Development Application: City of Melville
Six Storey Mixed-Use Development
65 Canning Beach Road, Applecross

PREPARED FOR: GPG NO. 6 PTY LTD
PREPARED BY: ALLERDING AND ASSOCIATES

November 2021

DESIGN REVIEW PANEL RESPONSE

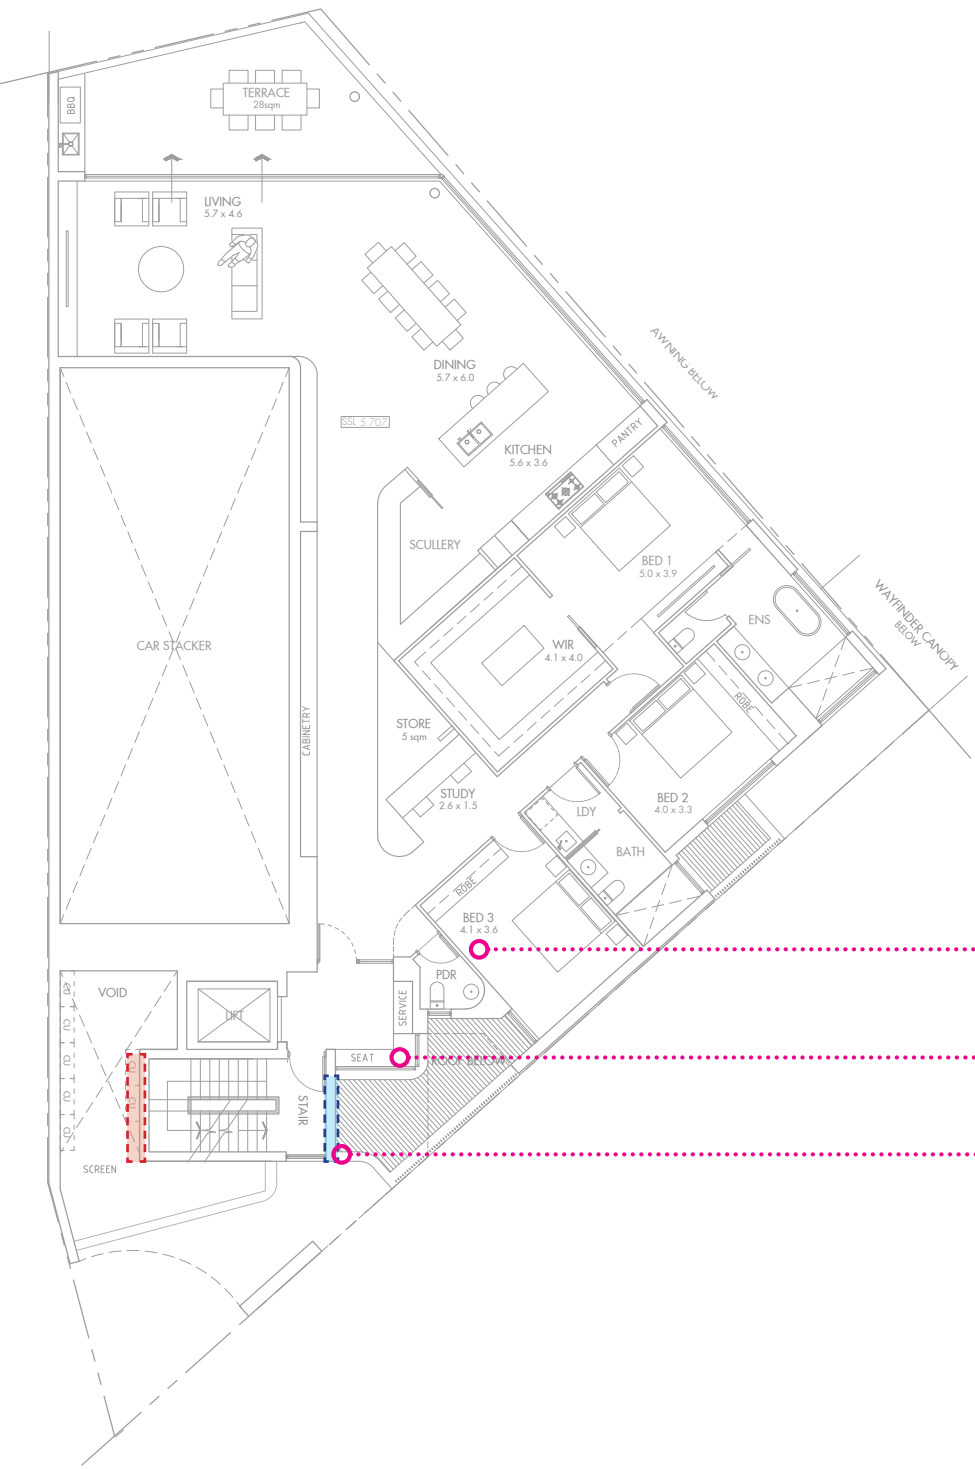
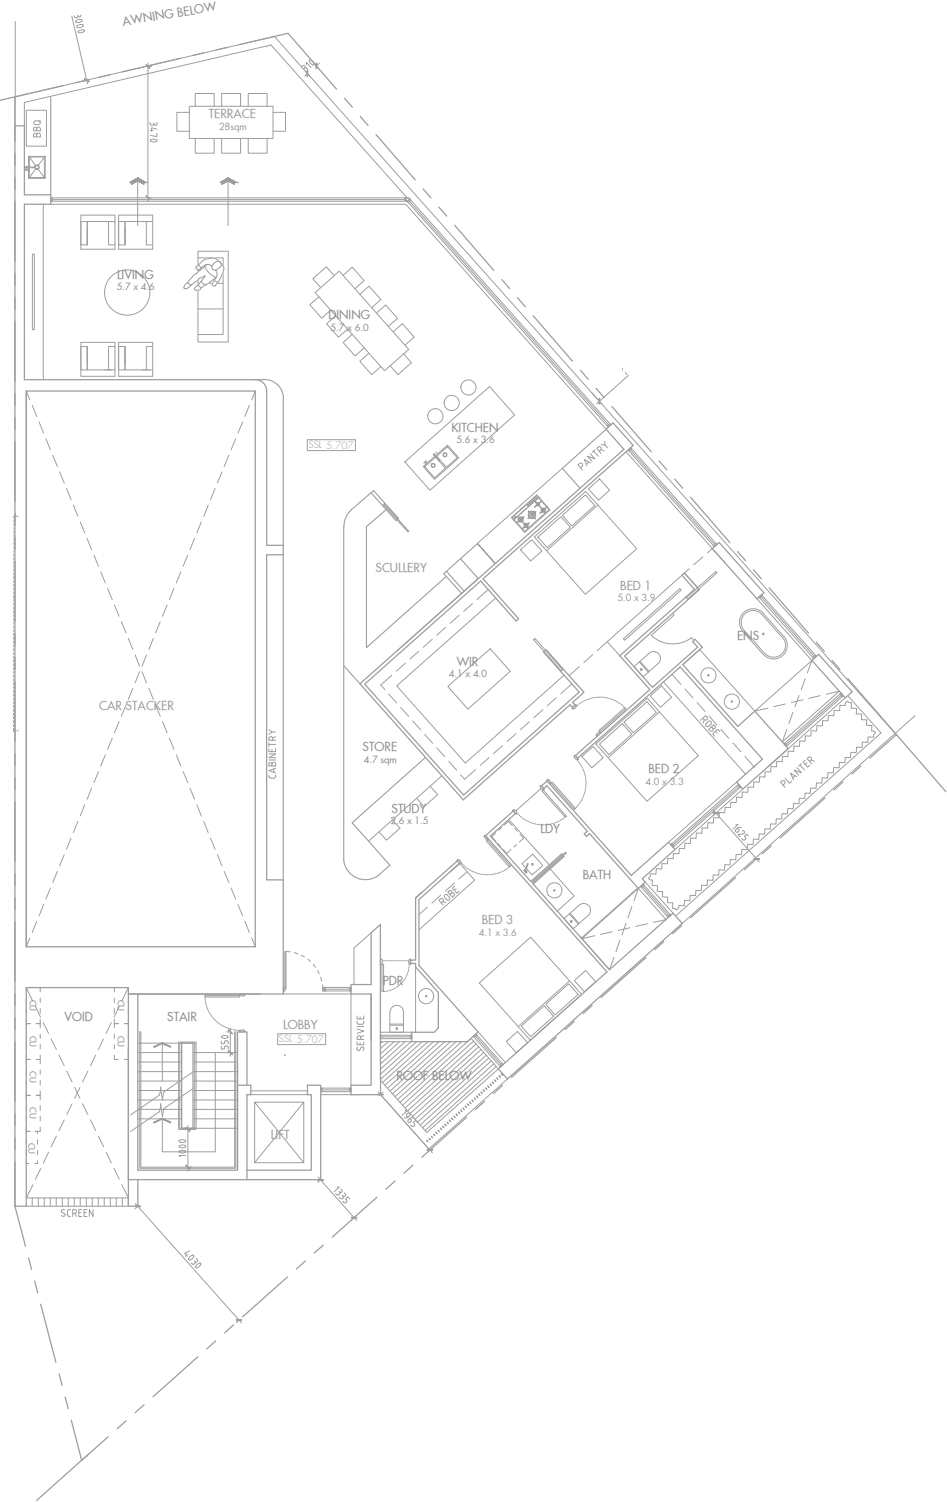
INCREASE TO COMMERCIAL
TENNANCY AND INCREASE
STREETSCAPE ACTIVATION

CROSSOVER WIDTH DECREASED
to increase pedestrian interaction
with streetscape

Fire Services and amenities
integrated thru ENGAGEMENT OF
FIRE ENGINEER

Secure permeable enclosure
added to Entry to INCREASE
SECURITY

INCREASE SETBACK to structure
from adjacent lot as a provision
for future adjoining development

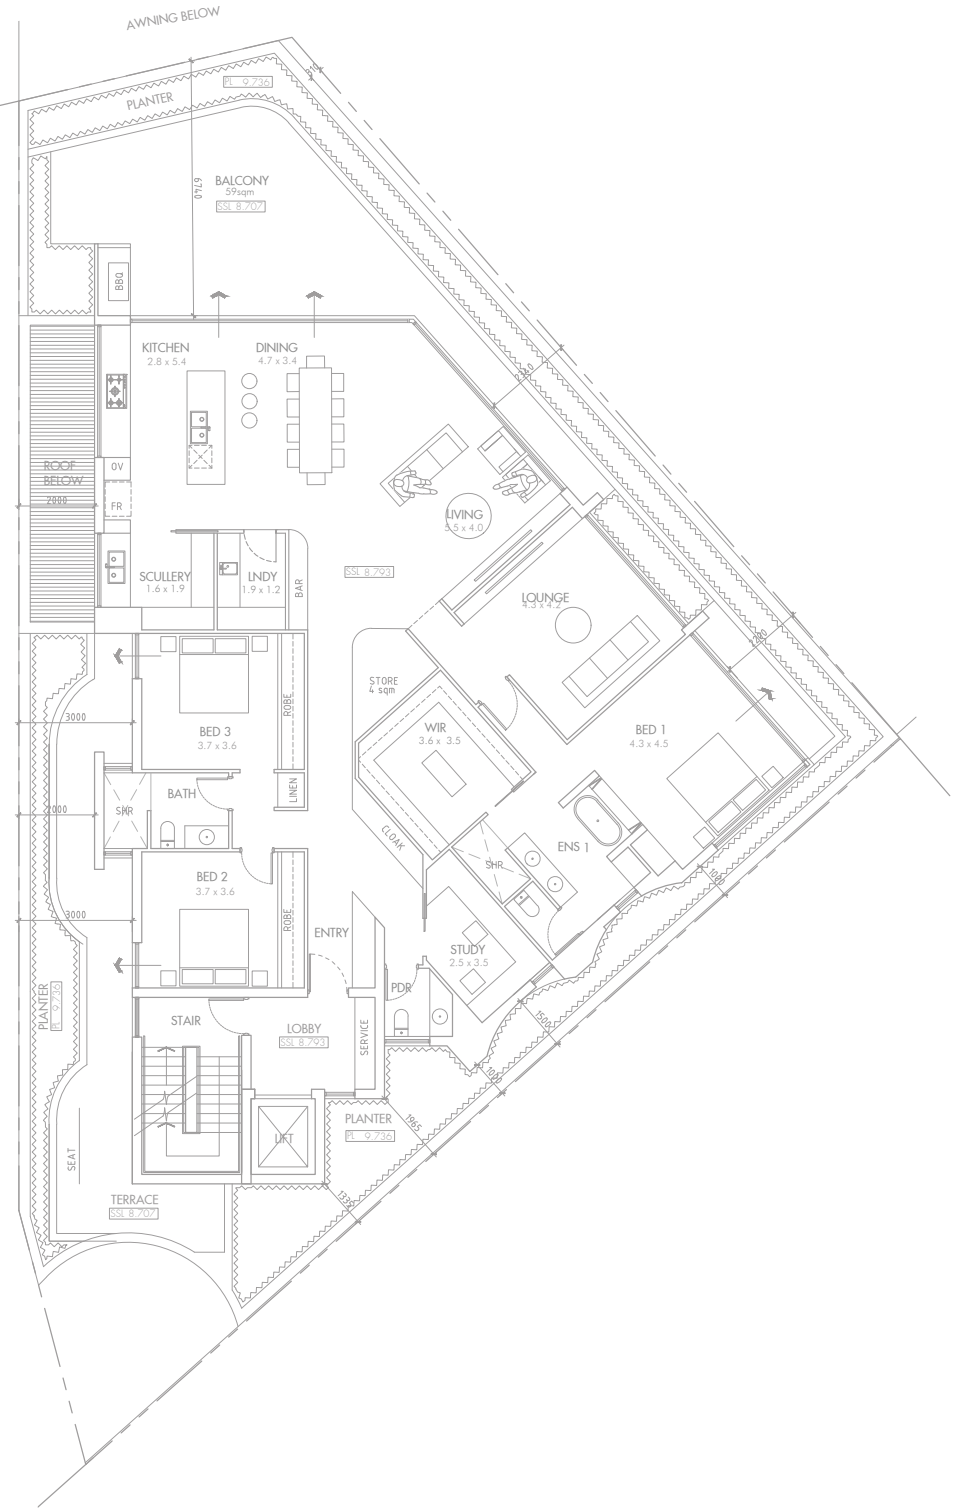
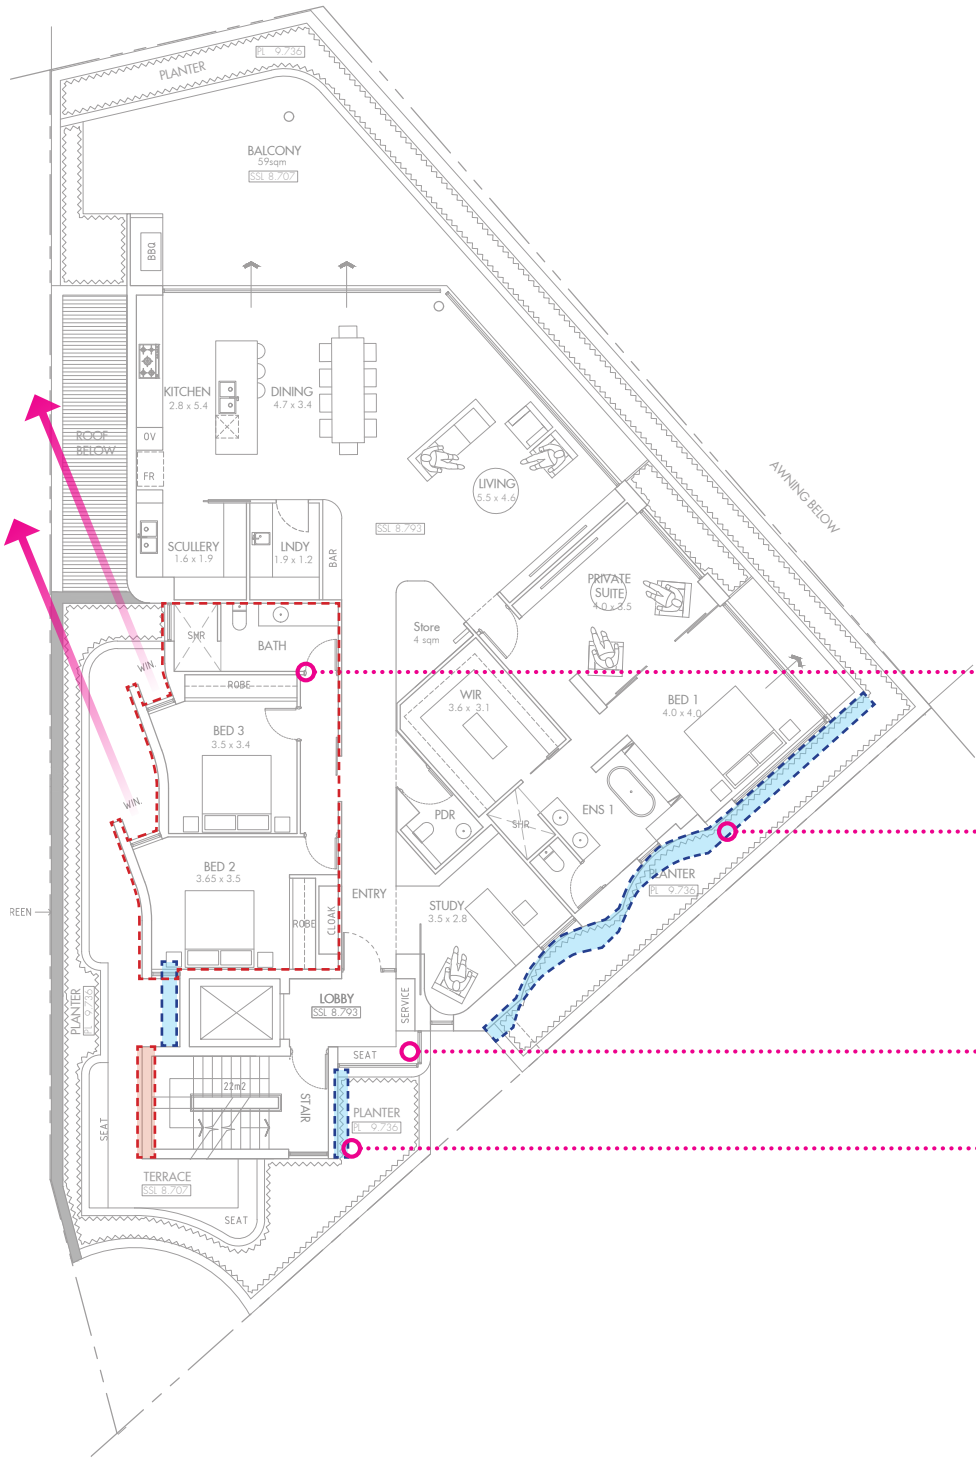
REDESIGN of internal floor plate
to IMPROVE EXTERNAL VIEW
CONNECTION to Bed 2 + 3

INCREASE SETBACK to structure
from adjacent lot as a provision
for future adjoining development

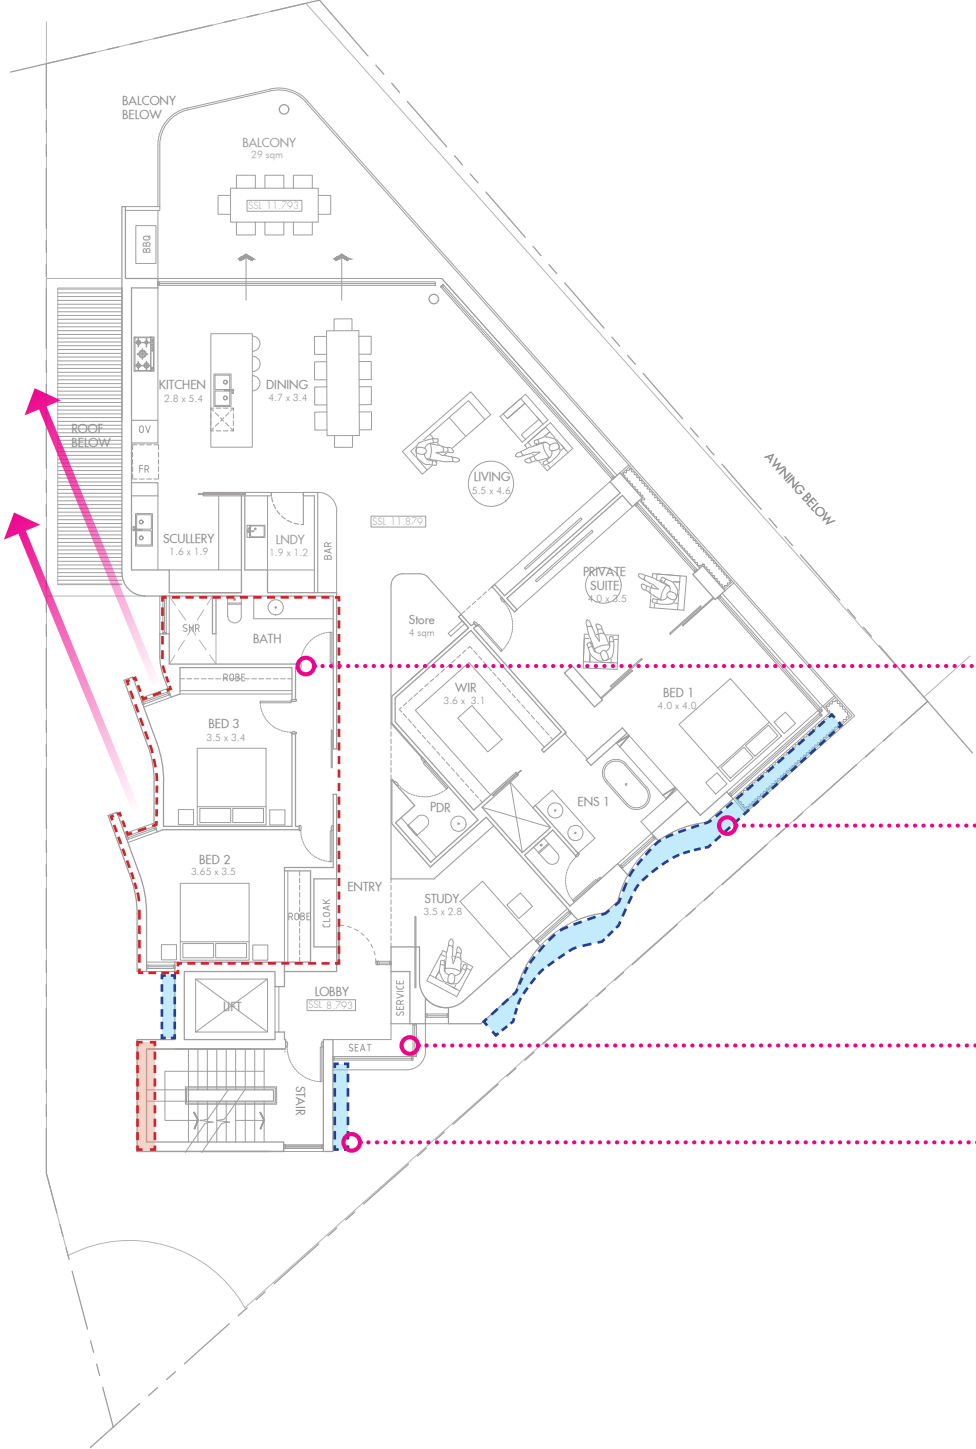
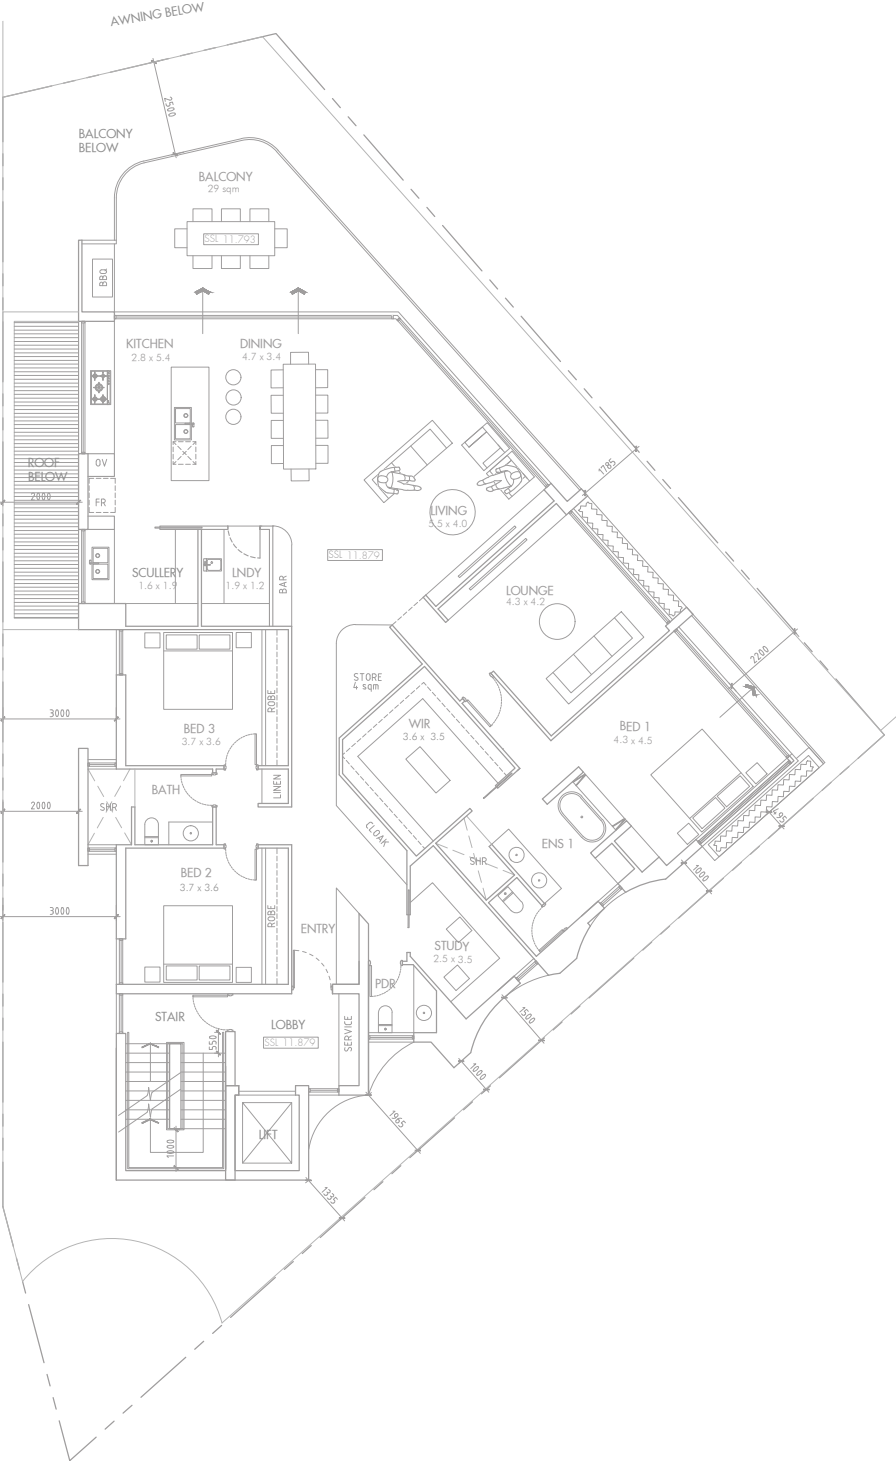
Introduction of aperture for
external environment aspect to
apartment Private Lobbies

INCREASE SETBACK to structure
from adjacent lot as a provision
for future adjoining development

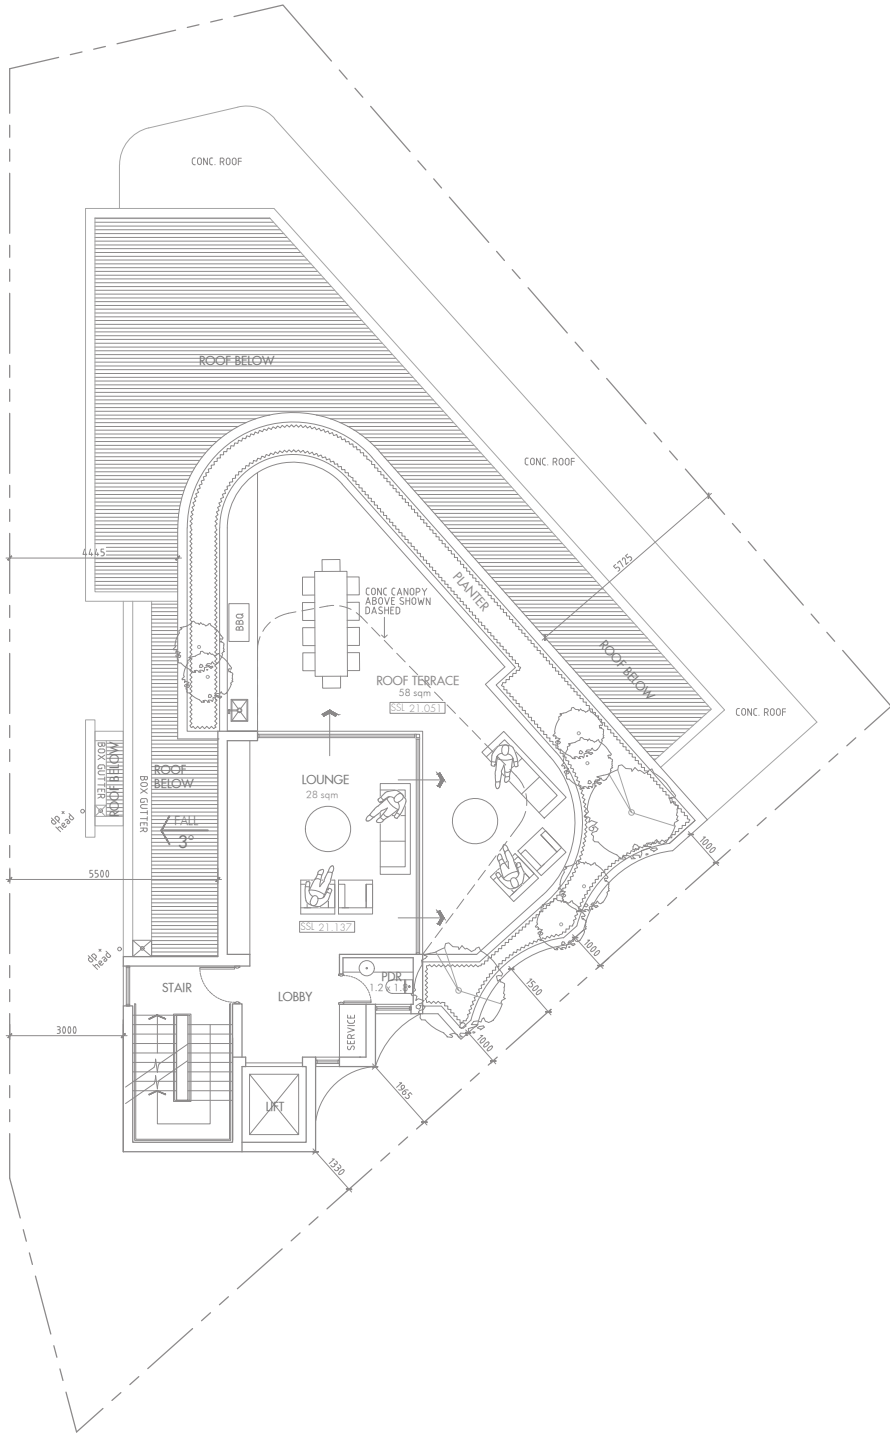
Introduction of aperture for
external environment aspect to
apartment Private Lobbies

INCREASE SETBACK to structure
from adjacent lot as a provision
for future adjoining development

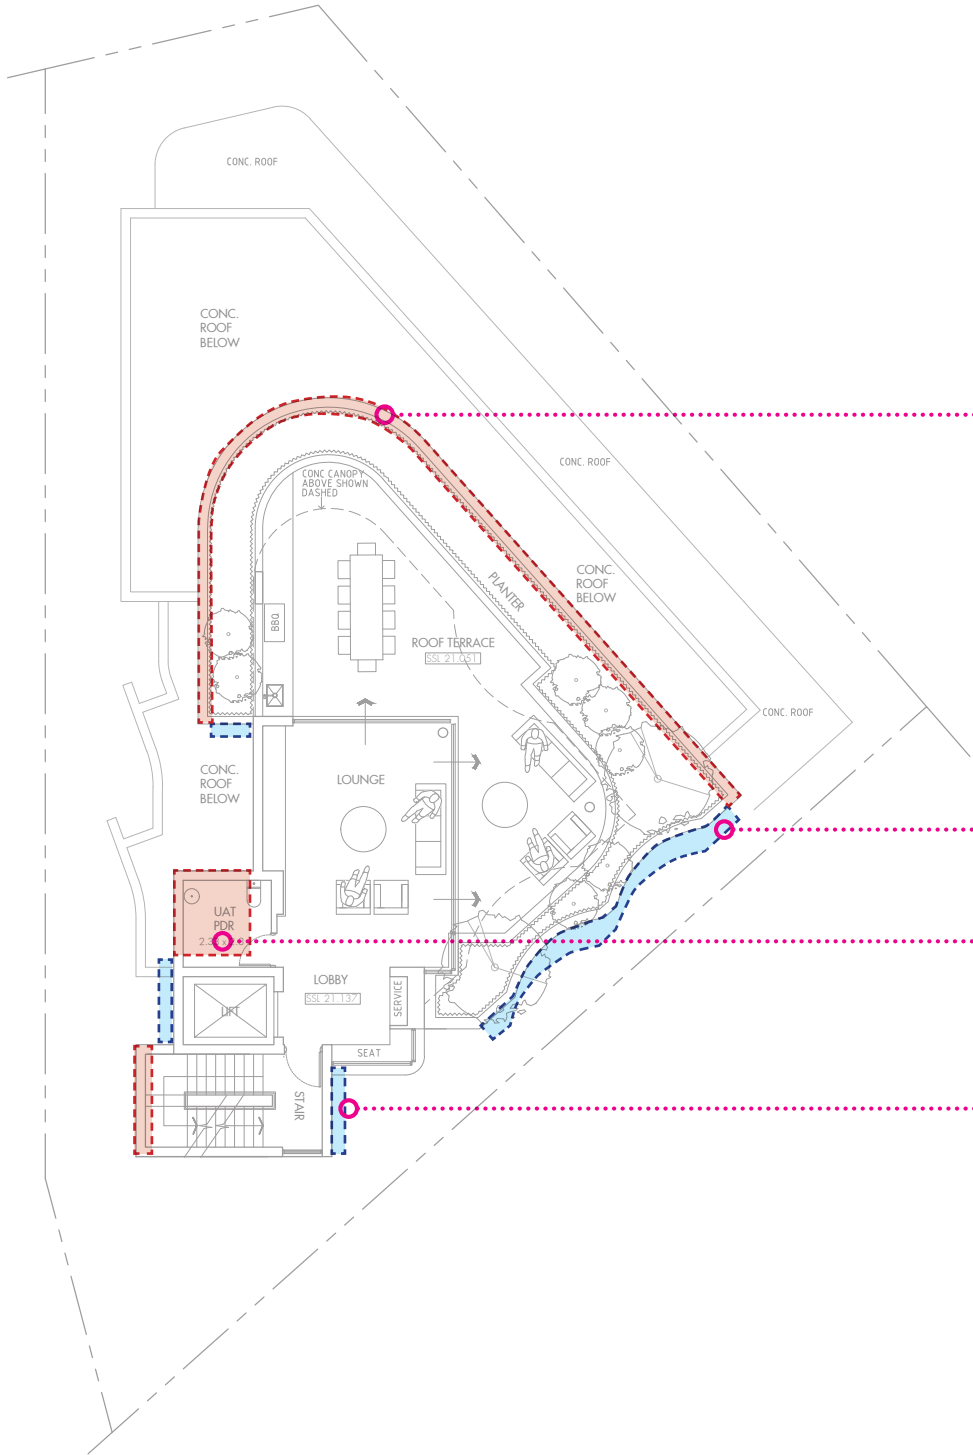
INCREASE PLANTING to leading edge of building to provide greater plant diversity opportunity and connection to landscape
